CS Memorandum No. 1346

To: Distribution
From: Susan MacKenzie, Document Control Manager 
Date: January 30, 2013
Reference: Project No. M544.1, Contract No. CS-149
Task No. 1-8.02, Change Control
Subject: Configuration Management Board Meeting No. 111

CMB Meeting Minutes #111

SUBJECT: Configuration Management Board Meeting # 111 – Rev. No. 0

THIRD STREET LIGHT RAIL PROGRAM PHASE 2 - CENTRAL SUBWAY TUNNELS		CONTRACT NO. 1252
UTILITY DEMOLITION TBM RETRIEVAL SHAFT CTL 80+00 TO 82+25		SFMTA CONTROL NO. CL-18035
DRAWING NO. UD-701	REVISION 0	SHEET NO. 38

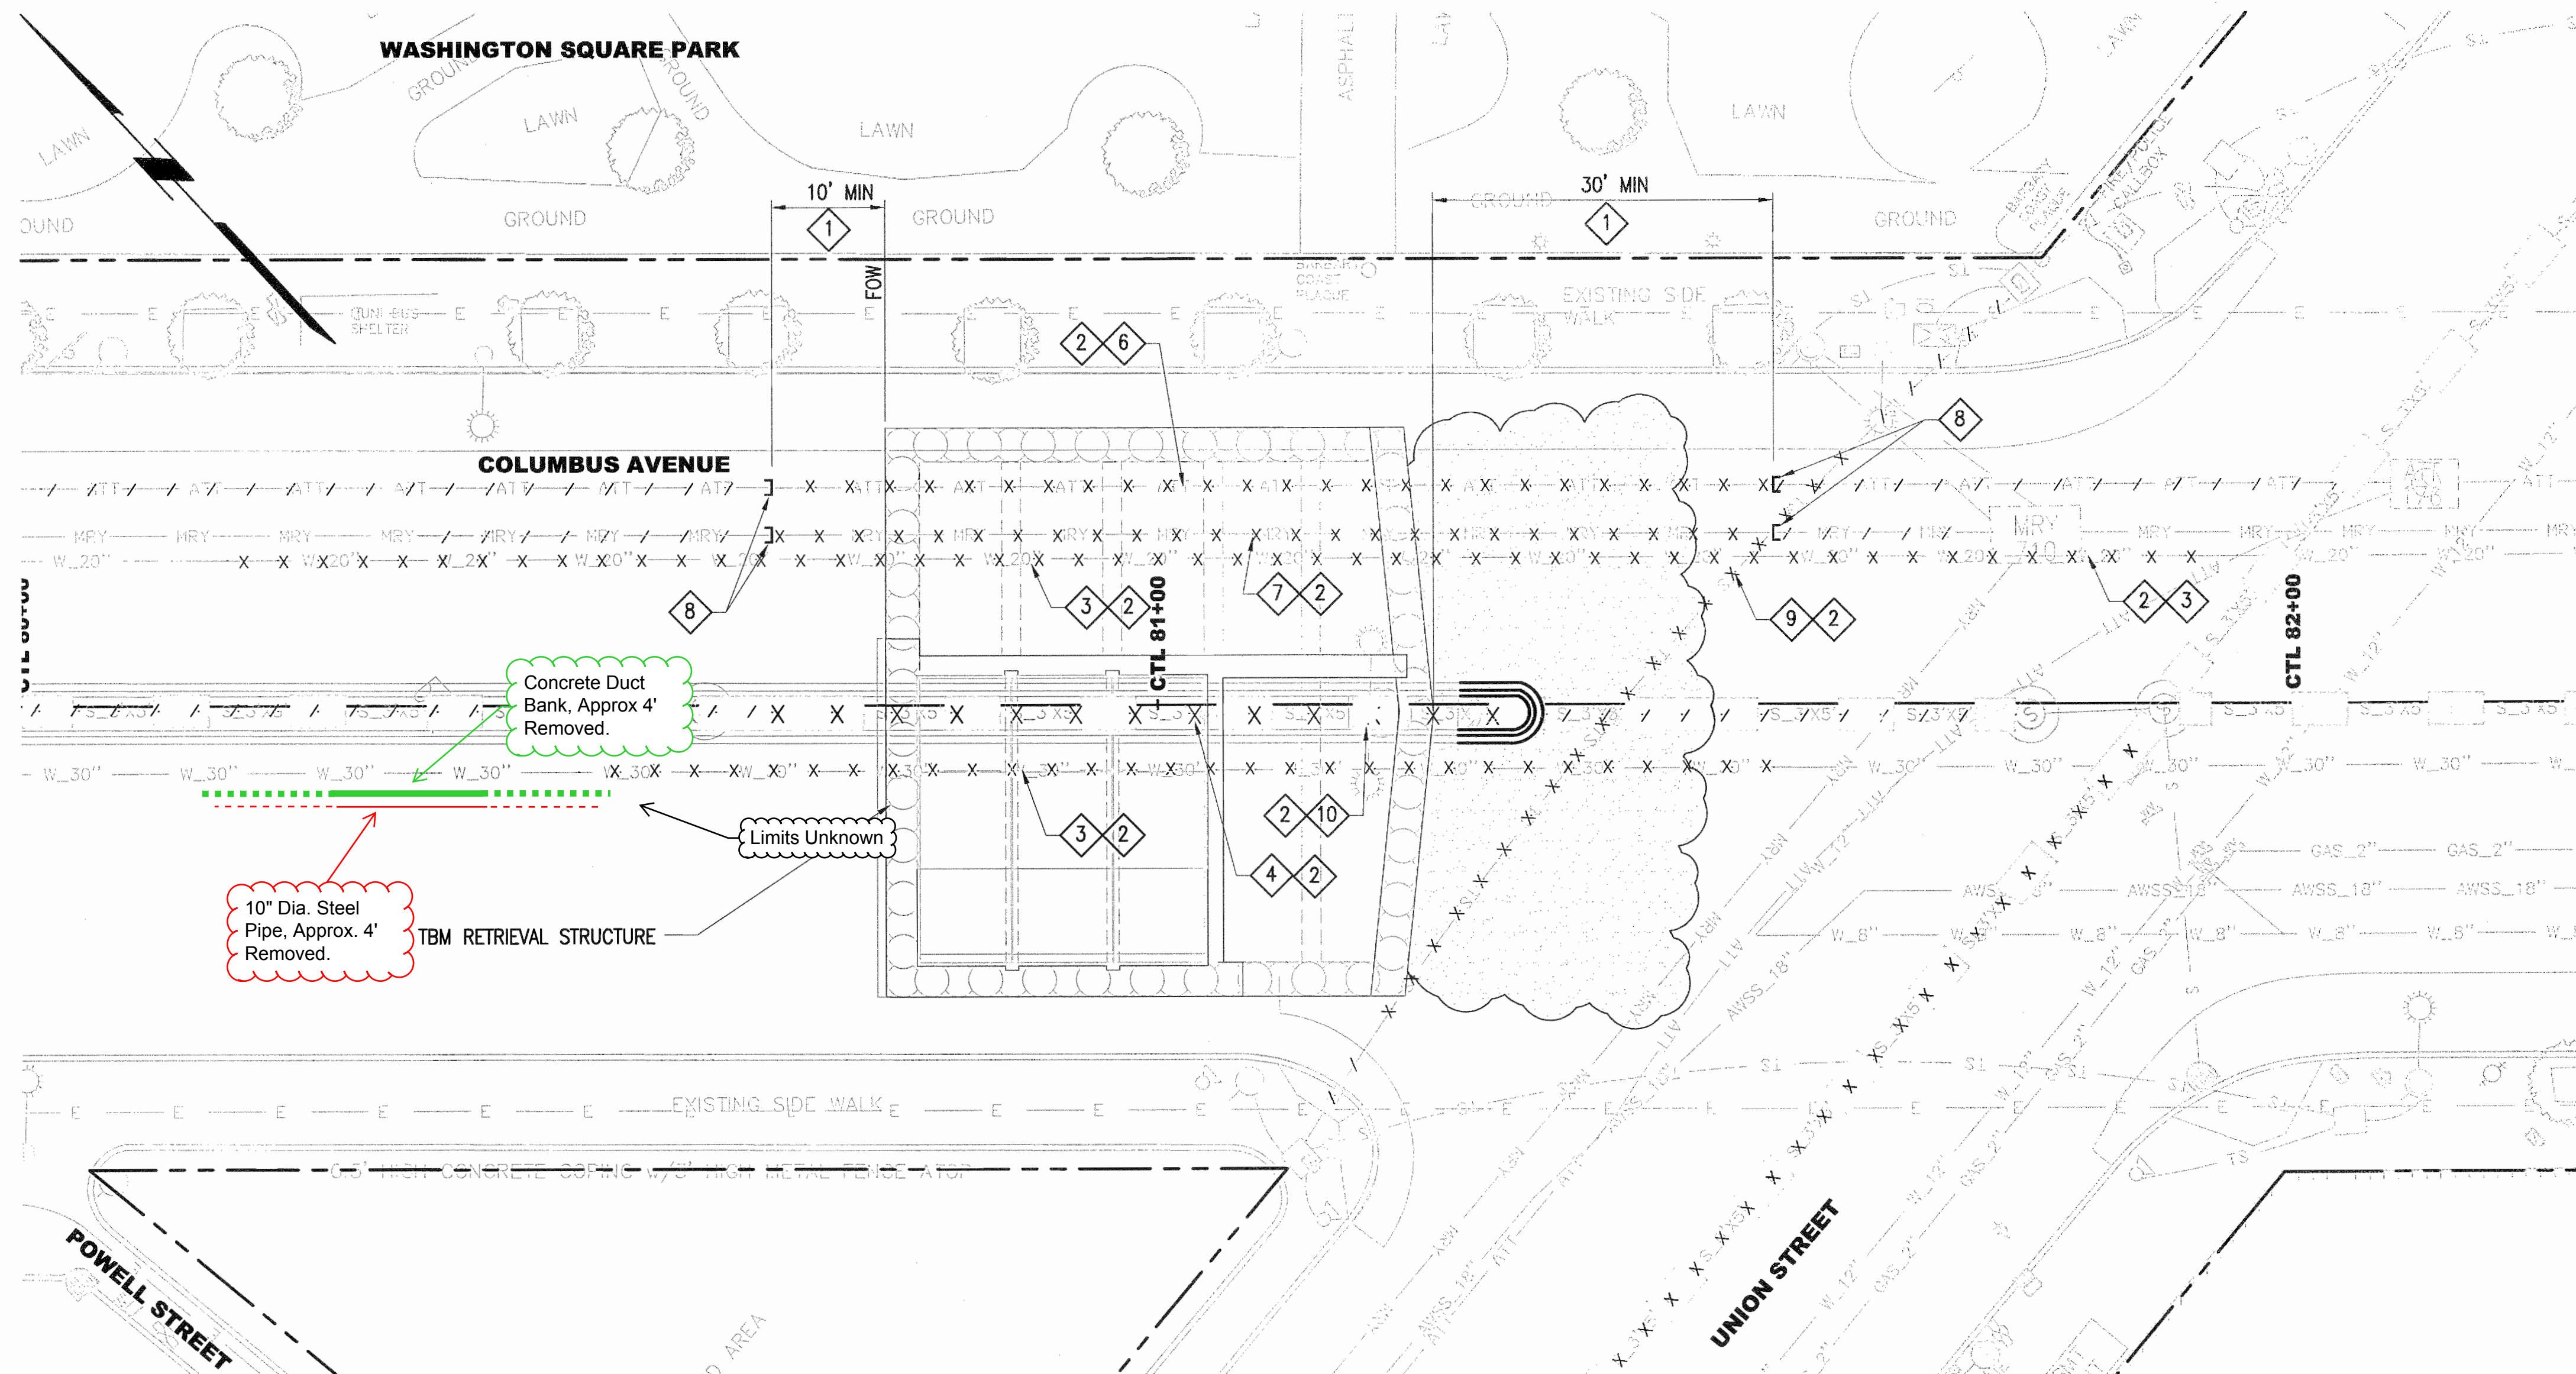
General Scope: This estimate contains the cost to remove unmarked 10" steel pipe discovered at CTL 80+33 during the retrieval shaft work on Columbus Street.

Sta. 164+60, Panel P-9

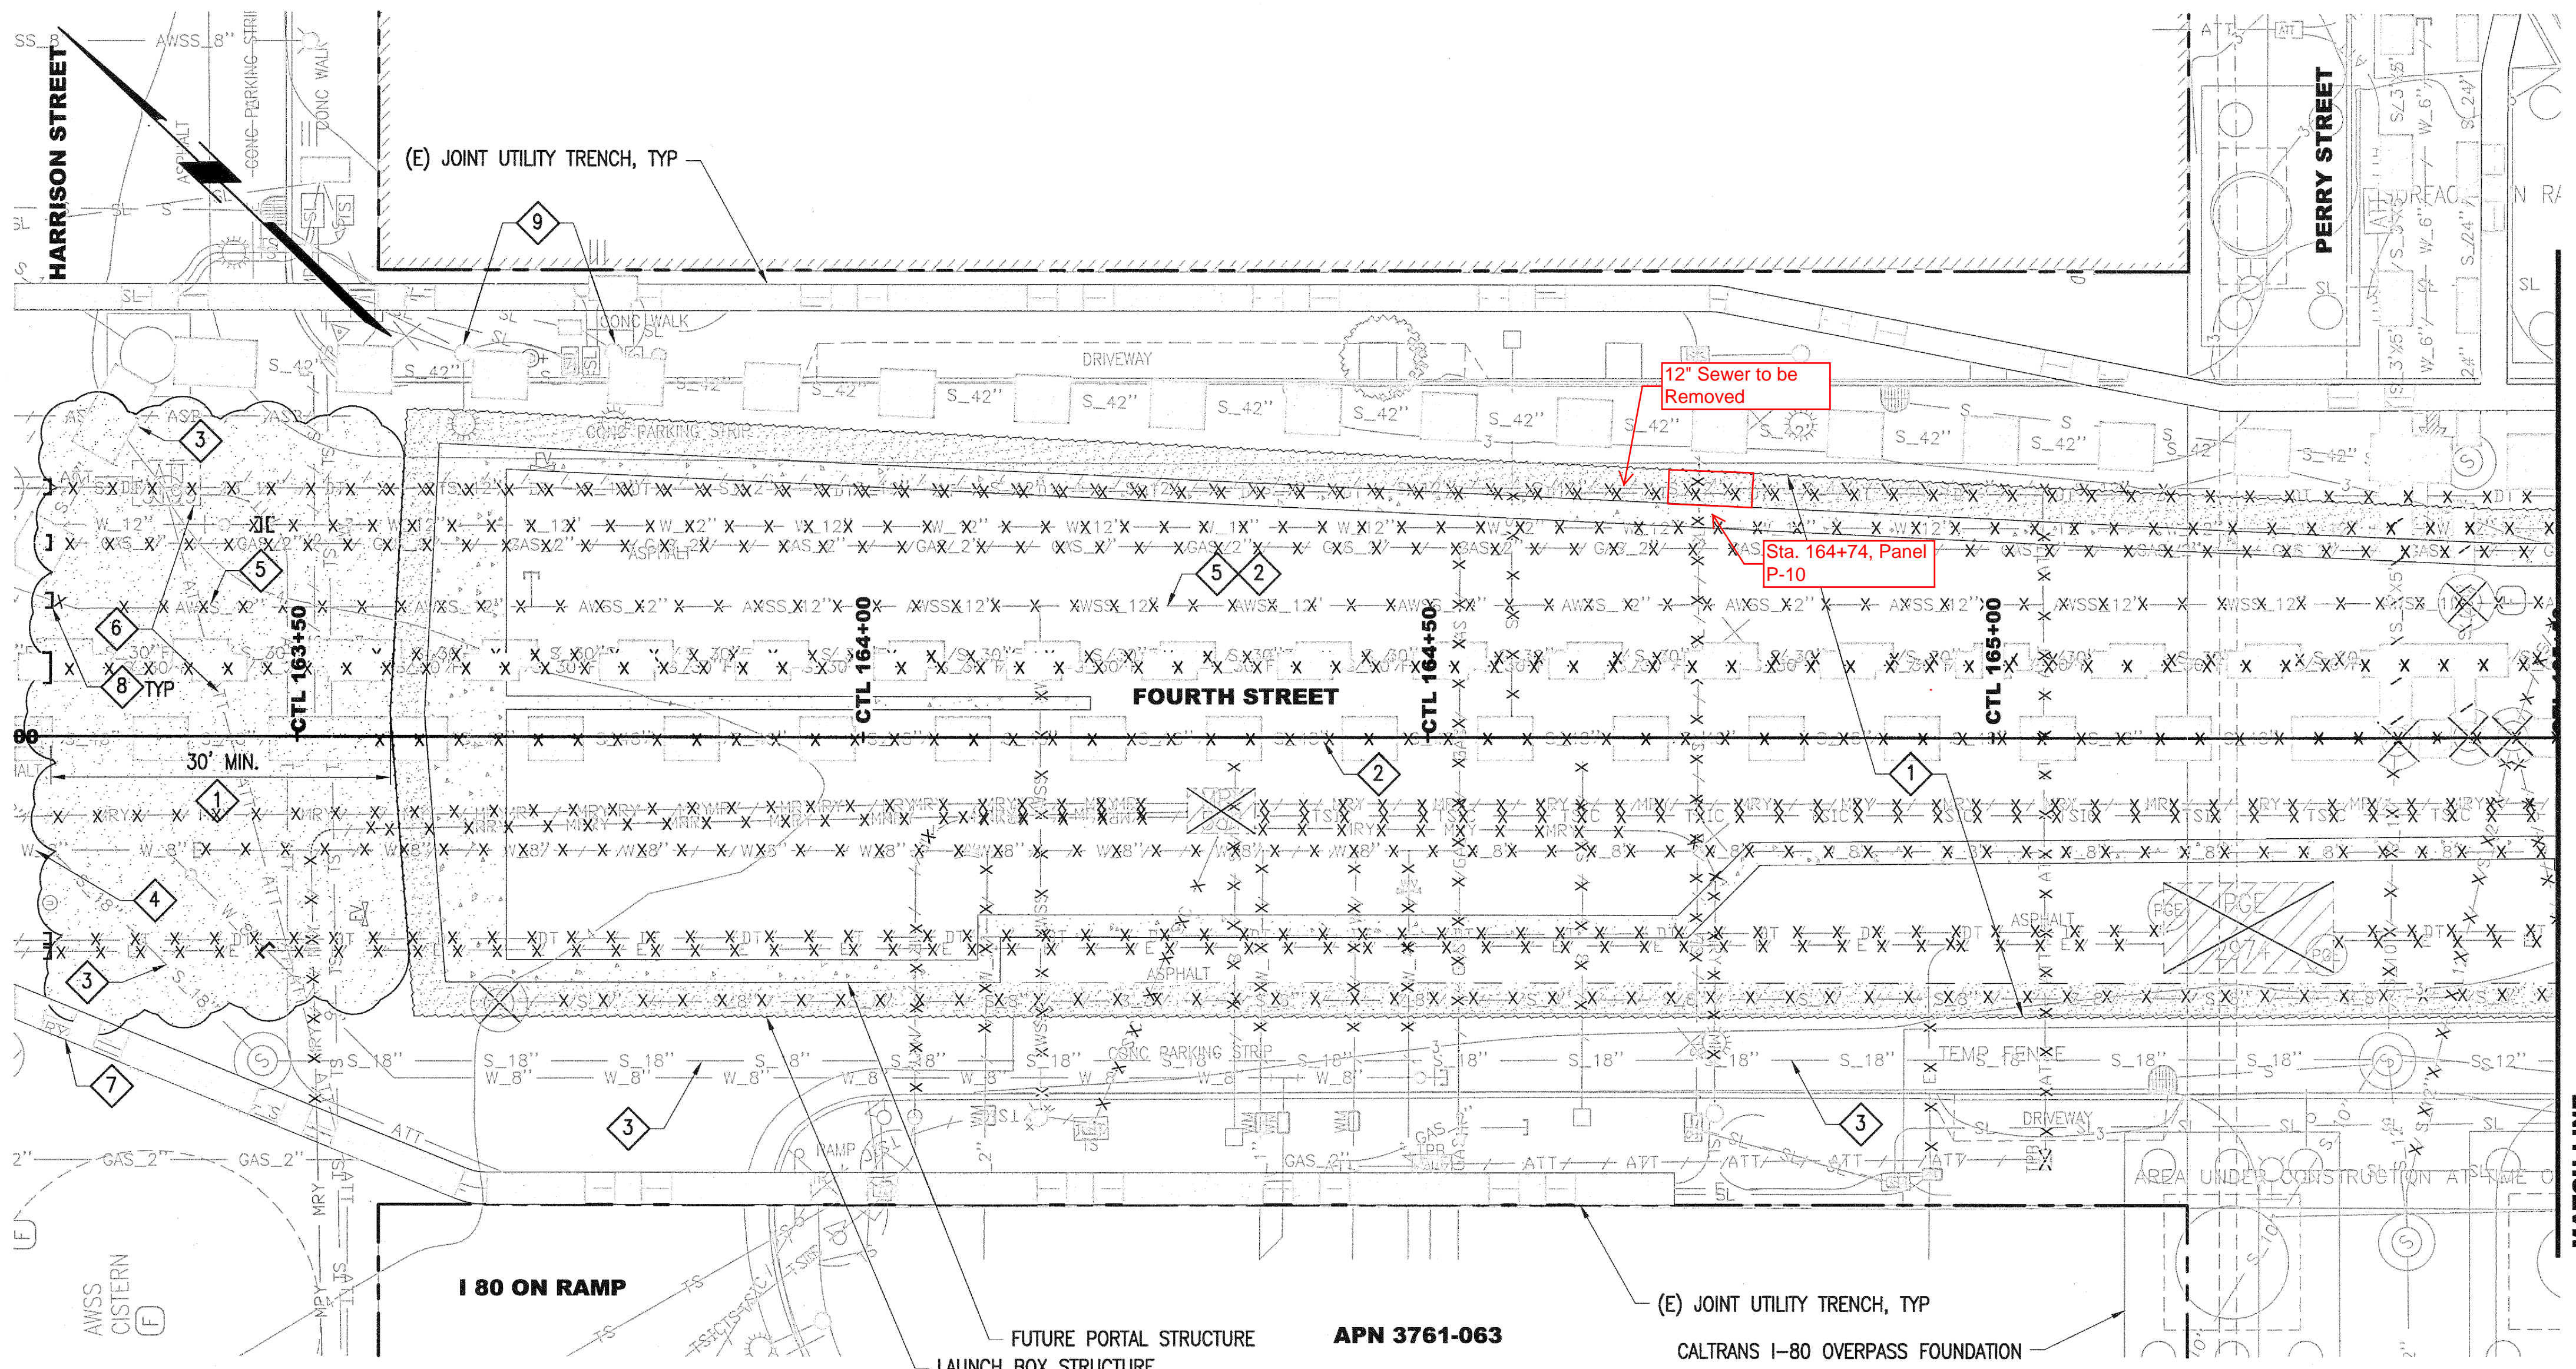
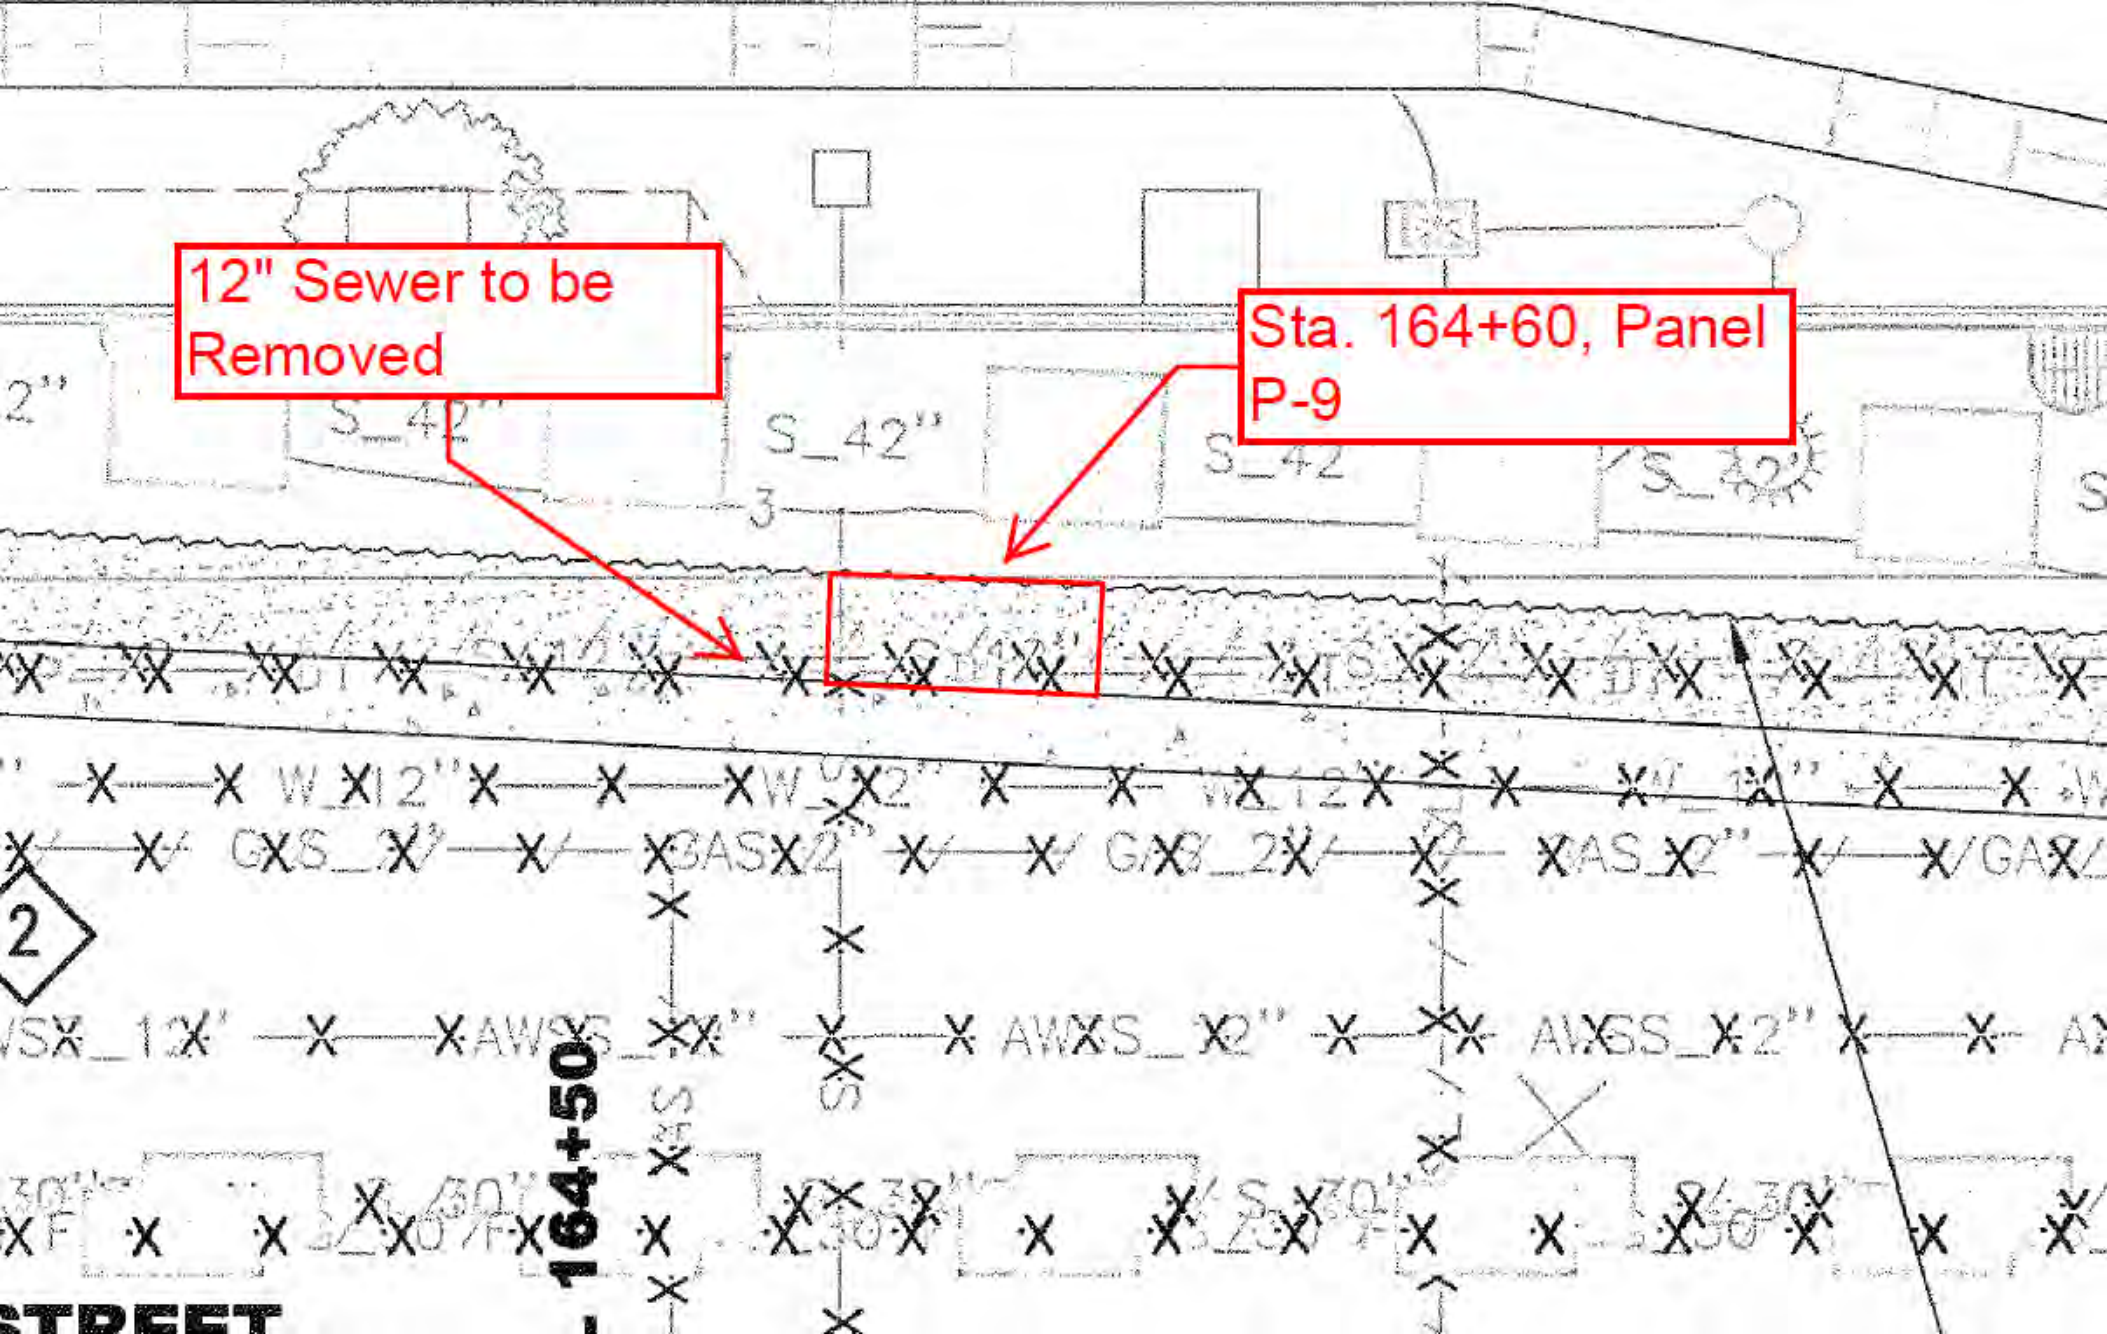
Facts: On November 7th 2012, the Contractor encountered concrete encasement around a 12 inch clay sewer pipe within Slurry Wall (SW) panel P-9 at the TBM Launch Box approximately 8 feet below the top of the SW guidewall. The concrete encasement caused the SW to deviate from the designed excavation limits. To correct the verticality of the panel excavation, the panel was backfilled with lean concrete and re-excavated as agreed upon by the RE.

This change affects a critical path activity. SFMTA inspectors documented an impact of approximately 5 days to SW P-9. We have asked the Contractor to combine the TIA for CORs 62, 65, and 67 and we have not yet received the TIA.

Justification: Drawing UD-502, Rev. 0 does not indicate the presence of the concrete encasement within the footprint of SW panel P-9. The concrete encasement prevented SW construction from occurring as originally planned. RE has evaluated the conditions outlined in Article 3.04 and found that: conditions differ materially and conditions caused the scope of work to increase.
